LFPCN-DI-BTA-2025-001/01

Product Change Notification for Littelfuse: Addition of in house second source for TO-268-3 Discrete IGBTs

1. Comparison: Device Marking

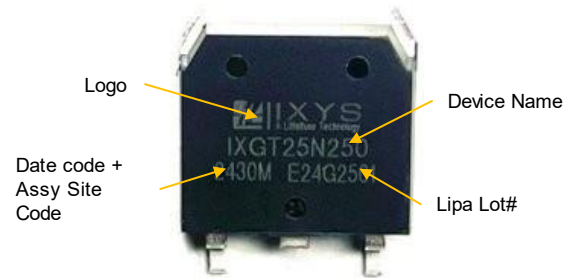
Item	OSAT	Lipa	Change (Y/N)	Risk	Remarks
Logo			Y	Low	Change to Littelfuse Logo
Part name	Device Name	Device Name	N	No Risk	No change
Date Code	FPMDDYY	YYWW	N	No Risk	No change
Lot #	Fab lot #	Lipa Lot #	Y	Low	Lipa uses Lipa format . Wafer lot number is traceable thru Lipa MES system using the lot number
Assembly Line Code	P	M	Y	Low	Site location code
